# USB Type-C ENGINEERING CHANGE NOTICE

**Title: Cable Electrical requirement**

**Applied to: USB Type-C Specification Release 1.0, August 11, 2014**

### (c) Section 3.7.3.2.2, Figure 3-45, Page 79

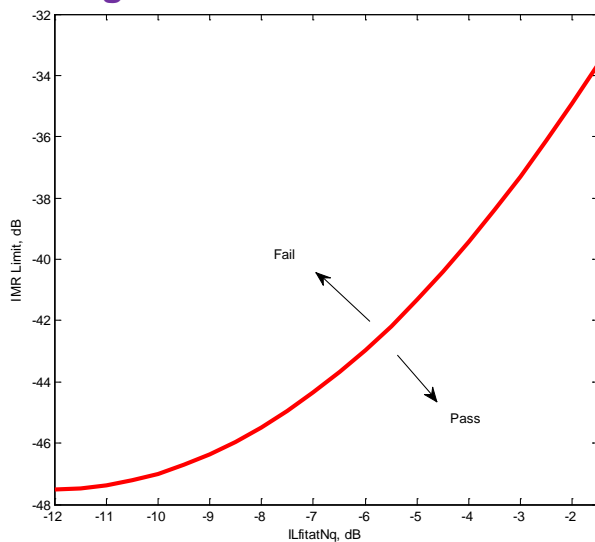
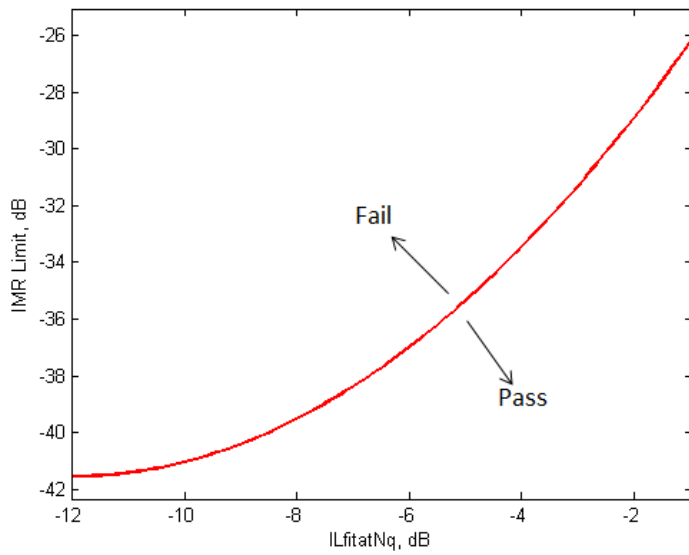
Test data of Type-C to Type-C cables indicate the electrical requirements are too tight in the specification. The changes relax the electrical requirements without significant impact on the system. The changes are applied to Type-C to Type-C cable and to Type-C to legacy cable. For Type-C to Type-C cable, the changes include relaxed IMR, relaxed IRL and reduced fMAX. For Type-C to legacy cable, the changes include relaxed IMR and relaxed IRL.

$$IMR \leq 0.126 \cdot IL_{fitatNq}^2 + 3.024 \cdot IL_{fitatNq} - 29.353$$

$$IMR \leq 0.126 \cdot IL_{fitatNq}^2 + 3.024 \cdot IL_{fitatNq} - 23.392$$

(e) Section 3.7.3.2.4, Figure 3-46, Page 80

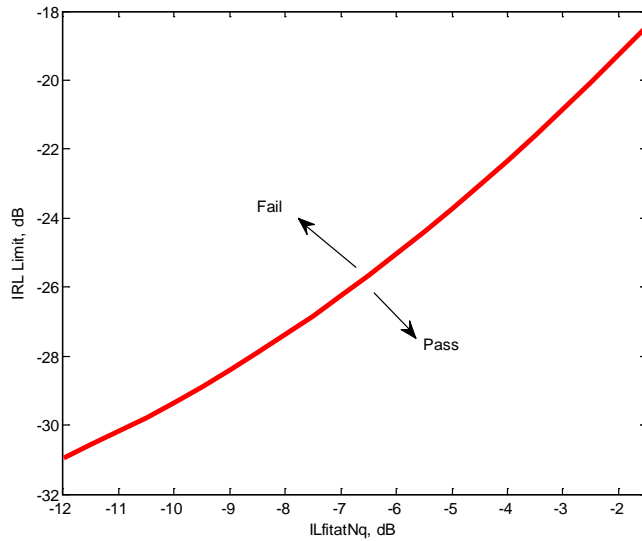
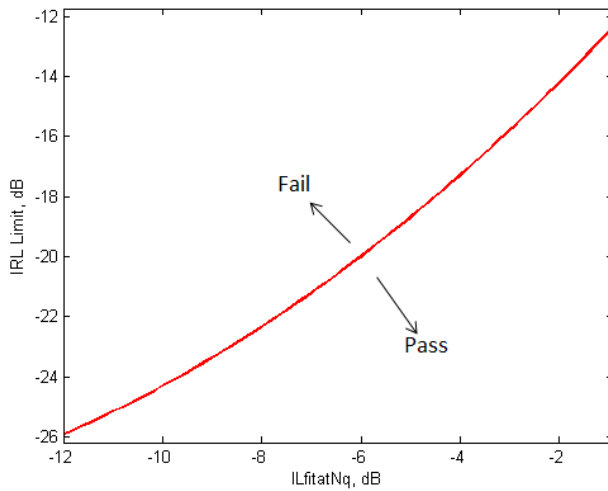
$$IRL \leq 0.046 \cdot ILfitatNq^2 + 1.812 \cdot ILfitatNq - 15.825$$

$$IRL \leq 0.046 \cdot ILfitatNq^2 + 1.812 \cdot ILfitatNq - 10.784$$

**(h) Section 3.7.4.2, Figure 3-52, Page 87**

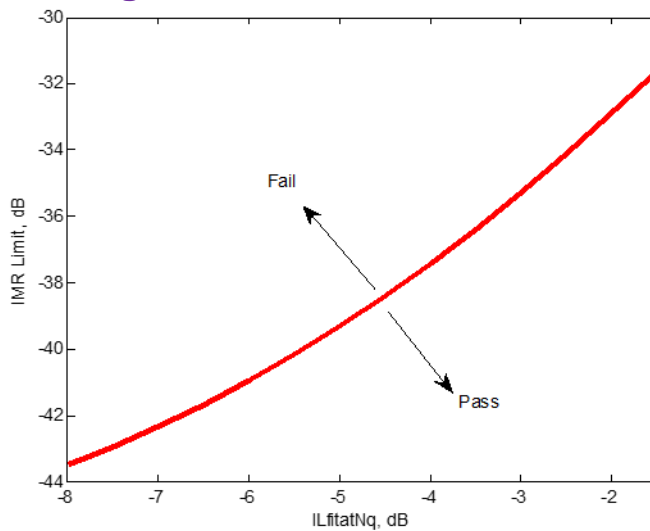
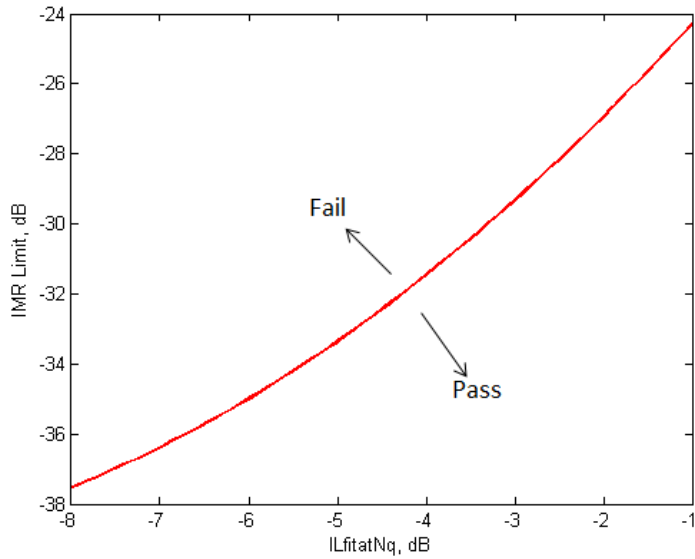
$$\leq 0.126 \cdot ILfitatNq^2 + 3.024 \cdot ILfitatNq - 27.353$$

$$\leq 0.126 \cdot IL_{fitatNq}^2 + 3.024 \cdot IL_{fitatNq} - 21.392$$

(i) Section 3.7.3.2.4, Figure 3-53, Page 87  
From: Figure 3-53

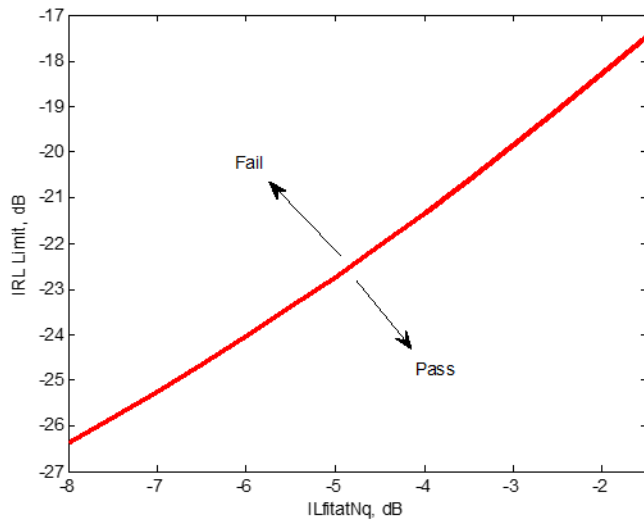
$$\leq 0.046 \cdot IL_{fitatNq}^2 + 1.812 \cdot IL_{fitatNq} - 14.825$$

$$\leq 0.046 \cdot IL_{fitatNq}^2 + 1.812 \cdot IL_{fitatNq} - 9.784$$
